Attachment A to IPN-84- 35

Proposed Technical Specification Changes

NEW YORK POWER AUTHORITY  
INDIAN POINT 3 NUCLEAR POWER PLANT  
DOCKET NO. 50-286

Description of Proposed Plant Modifications

IP3 480V SAFEGUARD BUSES UNDERVOLTAGE PROTECTION SYSTEM LOGIC DIAGRAM

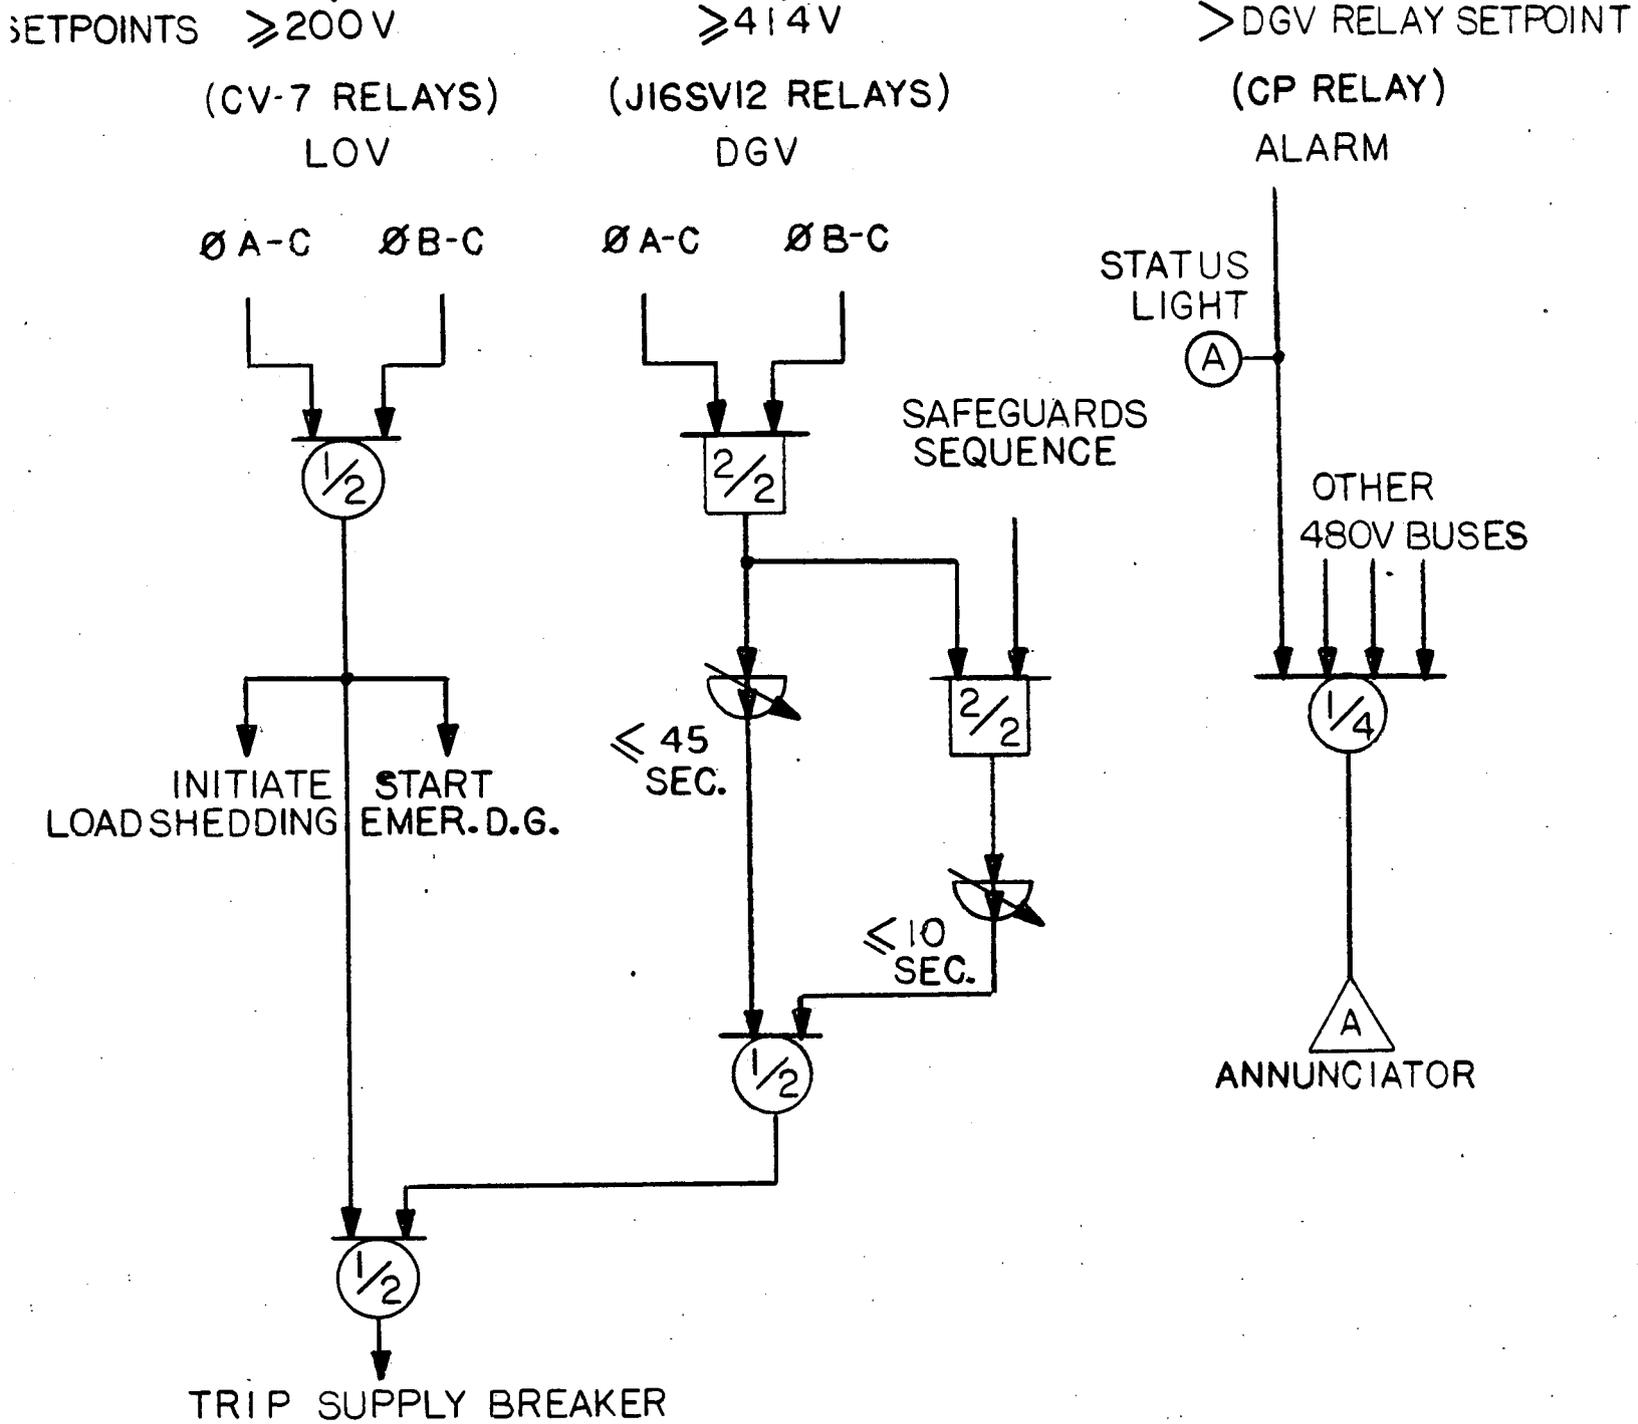
Based upon the DGV studies performed by the Authority on the Indian Point 3 electrical distribution system, the Authority is proposing to make the following modifications to the existing 480-volt safeguards bus undervoltage protection system:

(Refer to the attached sketch of the proposed logic for the modified 480-volt safeguards undervoltage protection system)

- 1) Retain the existing LOV relays. The existing protection scheme will be modified to provide for monthly testability. The added features will consist of test switches and indicating lights that will enable testing of one LOV relay per bus at a time, thus providing LOV protection through a one-out-of-one logic during testing. The technical specification setpoint proposed for these relays is  $\geq 200$  volts.
- 2) Retain the existing DGV relays. A modified protection scheme for continuous DGV conditions that is arranged in a two-out-of-two logic with a proposed technical specification setpoint of  $\geq 414$  volts and a time delay of  $\leq 45$  seconds will be provided (see Attachment A). This time delay is required for proper coordination with plant

transients as indicated above. For safeguards actuation coincident with a DGV condition, a bypass of the  $\leq 45$  second time delay will be provided. This bypass consists of a proposed technical specification time delay of  $\leq 10$  seconds to provide proper coordination and prevent spurious actuation (see Attachment A). The modified scheme will have provisions for monthly testability. The testing scheme will include provisions for testing of the DGV sensing relays and timers (see Attachment A).

- 3) Retain the existing undervoltage alarm relay, annunciator scheme and setpoint (as established by applicable alarm response procedures). Monthly testing of the alarm by technical specifications is proposed (see Attachment A).
